**From:** [Moore, Jackson W](#)  
**To:** [McCormick, Debra J](#)  
**Subject:** FW: Reworld Solutions, LLC (SW ID#64-09) 5/31 RAI Response Review  
**Date:** Tuesday, July 2, 2024 3:27:30 PM  
**Attachments:** [image001.png](#)  
[image002.png](#)  
[image003.png](#)  
[image005.png](#)  
[image006.png](#)  
[image007.png](#)  
[image008.png](#)  
[Portage PE 2019-09-13 Site Plan - Covanta Environmental Solutions.pdf](#)  
[image004.png](#)

**Subject:** Reworld Solutions, LLC (SW ID#64-09) 5/31 RAI Response Review

OLQ Engineering has reviewed your response to the request for additional information received May 31, 2024 (VFC #[83655581](#)) regarding the Reworld Solutions, LLC, permit renewal. We need the following additional information. Please acknowledge and respond by Monday. If not received soon, we will include them as compliance schedule requirements. Please include the attached certification statement with your response.

DESIGNED	DRAWN
DFH	JJB
PROJECT NO.	
C5003-5-19-00206	
DATE	
09/13/2019	
SHEET NO.	
C1.0

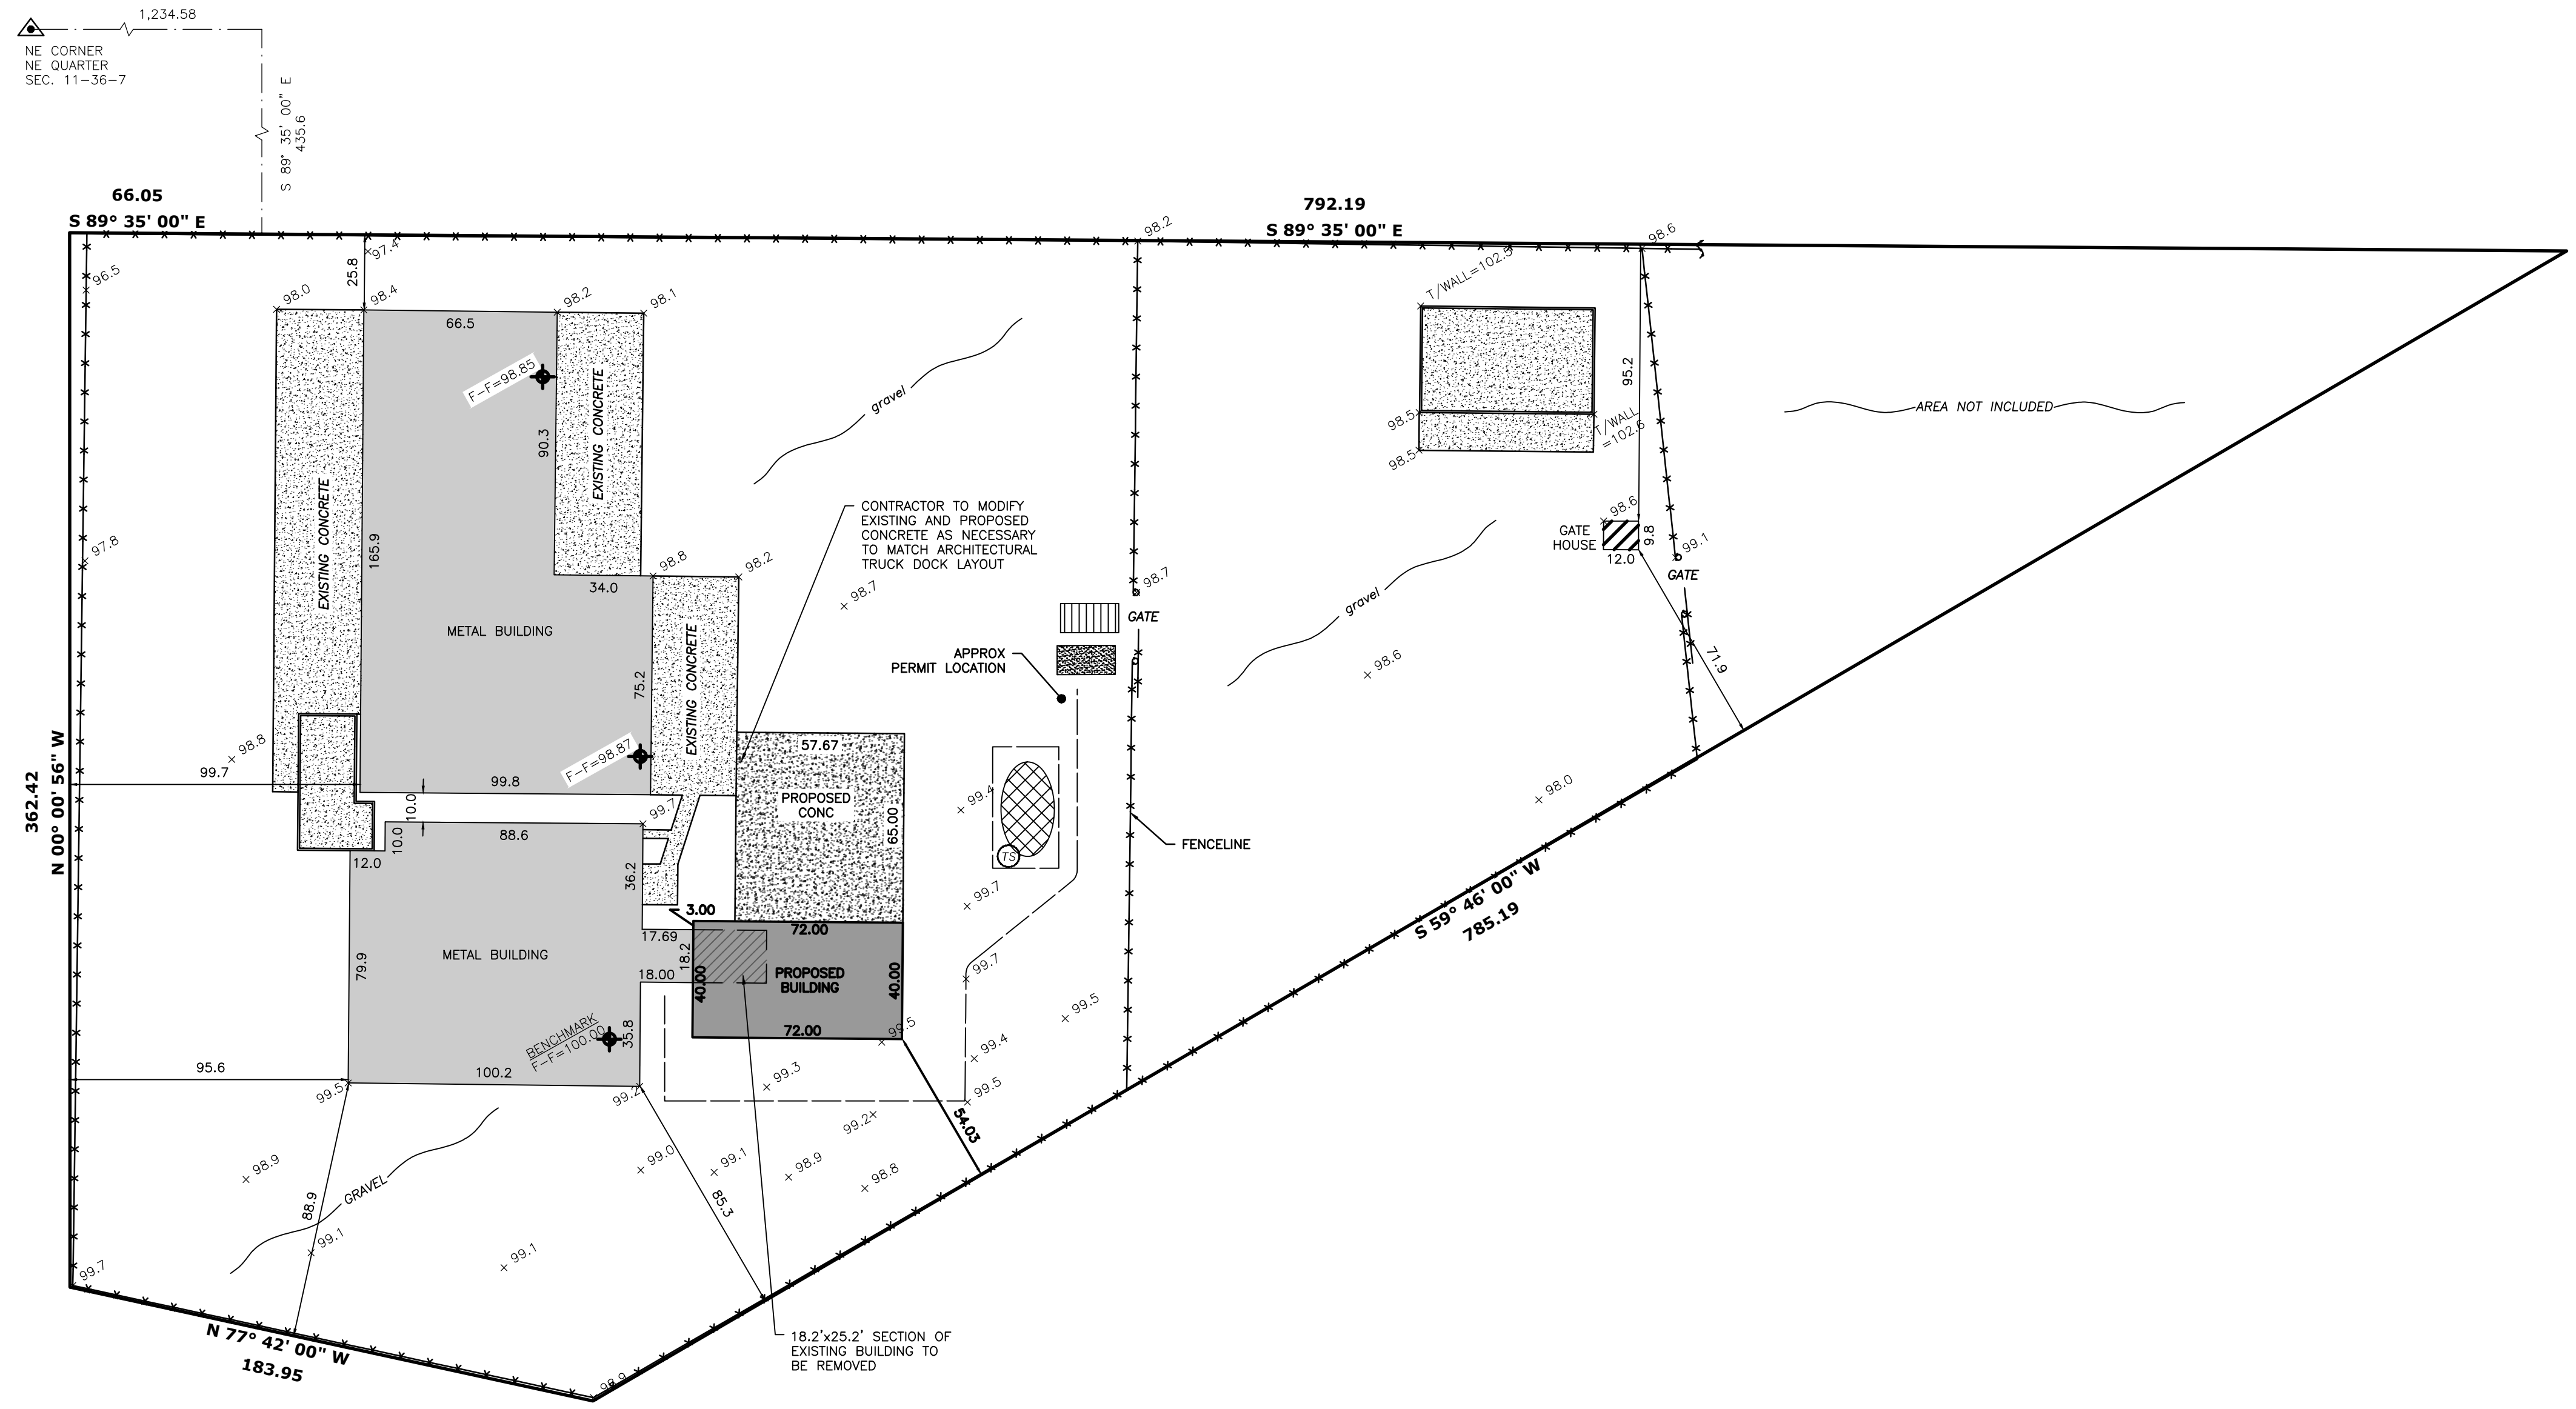
1. The facility name was recently rebranded as Reworld Solutions, LLC per correspondence dated April 30, 2024 (VFC #[83650210](#)). Update the applicant and facility names on the permit renewal application form (VFC #[83536840](#), pg. 6 of 102), as applicable.
2. The response to RAI on page 13 includes post-closure costs but does not include contingency cost. Include a minimum 10% contingency cost of the estimated closure and post-closure cost estimates.
3. Provide a legal description of the facility boundary certified by a professional land surveyor or Warranty Deed certified by the County verifying property ownership.

In response to your request for additional information attached is a site plan for the Reworld Portage facility, which provides a description of the property, certified by an engineer. Please let me know if this sufficient.
